1763 : **Batchbrook Cottage, Catsham**

Variation of Condition Document

The purpose of this document is to establish variations to the conditions in association with the approved application 2023/0360/FUL at Batch Brooke, Mulchelney Road, Baltonsborough, Glastonbury, BA6 8PQ.

Fig 4: Consented Elevations

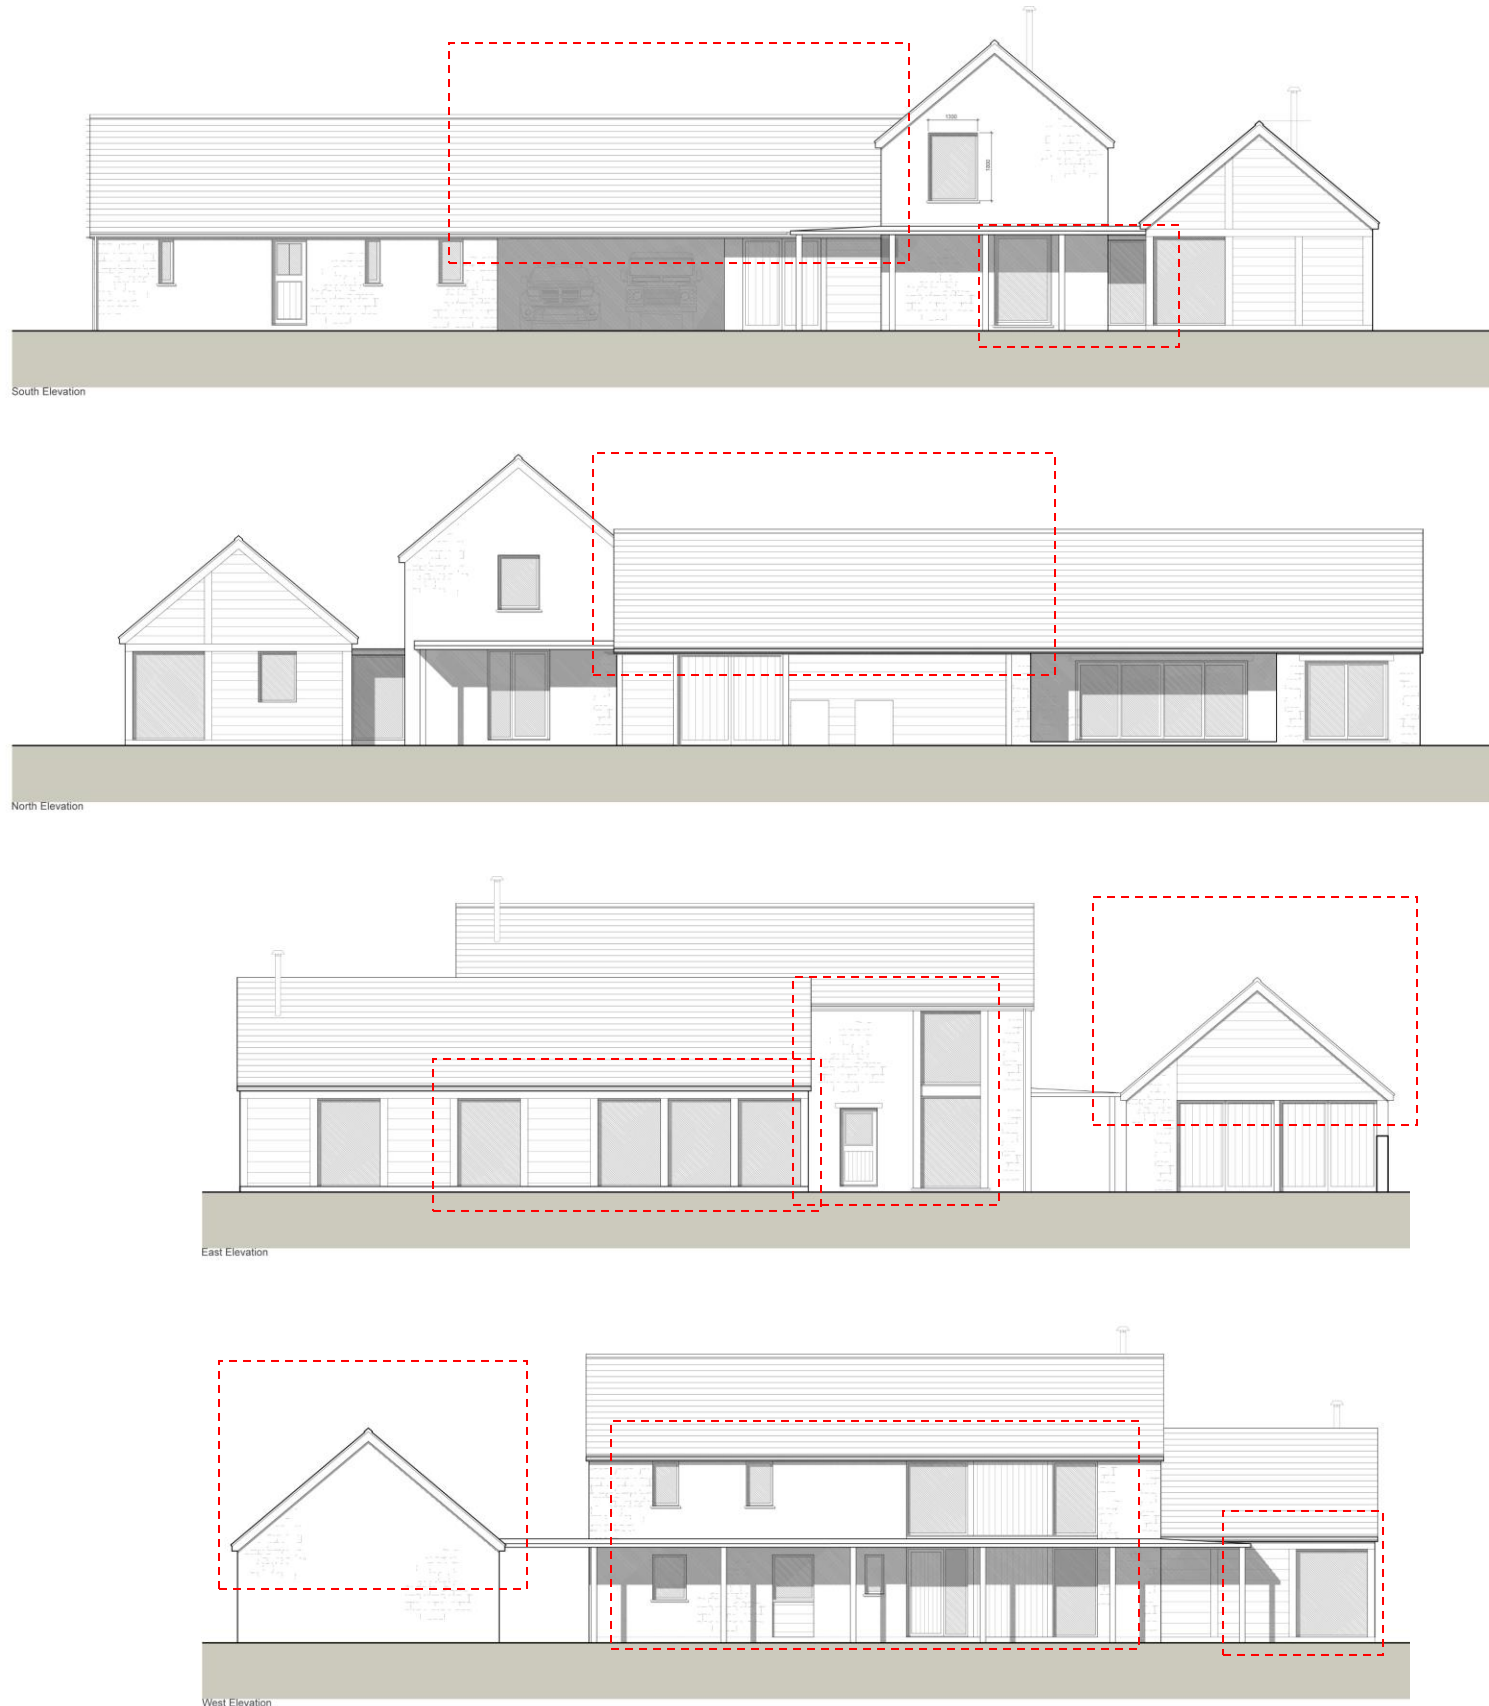
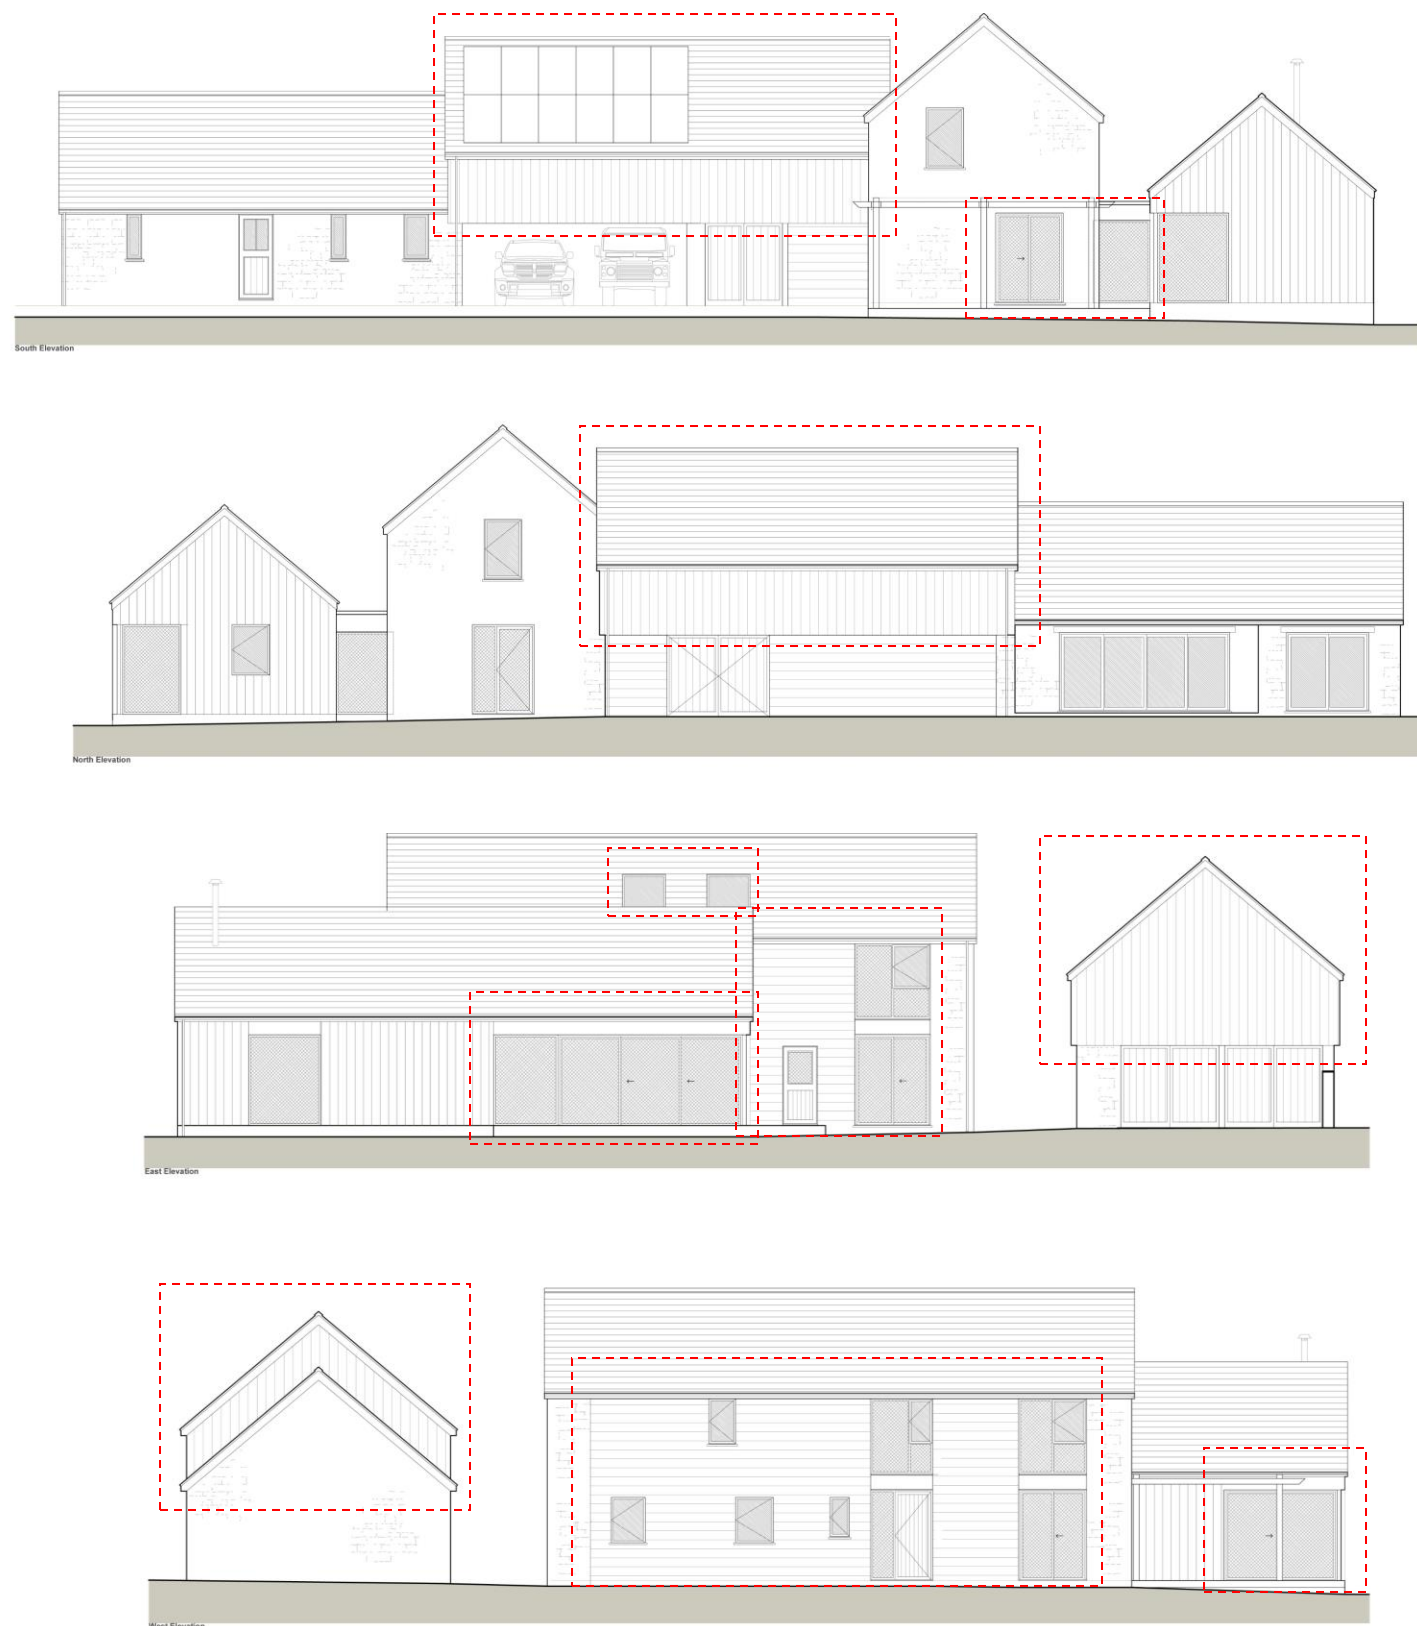
This application seeks to vary the condition on the consented scheme by removing the veranda that wraps around the principle elevation of the two-storey element, alter glazing with the loss of the single pane in the single storey element to the east and the widening of the glazing to the west in the Snug, bedroom 3 and Living and the link as mentioned in 2.2 and the increased height of the carport as mentioned in 2.3.

Material changes include, the varying of roof material from clay tiles to slate. The proportion of stone and timber cladding used on the two storey element of the dwelling and the loss of the expressed oak frame in the single-storey element of the dwelling.

The most considerable change to the appearance of the proposal is the increased height of the carport to incorporate a storage loft for the family. Additionally, the variation proposes to install PV panels to the roof of the carport for a sustainable approach to energy consumption. The ancillary building materials had originally been predominantly stone with timber cladding accents and clay tile roof, the variation proposes for it to be stone and timber clad with a slate roof.

The variation proposes to alter the two-storey element of the dwelling to have stone gables with infill timber cladding along the longitudinal elevations, with the removal of the veranda that wrapped around the principal elevation and the introduction of a pergola to the south elevation. The variation proposes the removal of the up and over glazing which has resulted in the increase of roof profile in the link. The single storey element has been proposed to have a minor variation from having expressed oak structure to solely being timber clad. All roofs proposed to be varied from clay tile to slate tile.

- South Elevation: The ground floor window in the two storey gable has been changed to a sliding door and the link glazing has been widened
- East Elevation: Introduction of rooflights into the two-storey element, full height glazing in the single storey element has joined one of the single panes of glazing with the sliding doors.
- West Elevation: Enlargement of the sliding doors in the single storey element and full height glazing in snug and bedroom 3 have widened
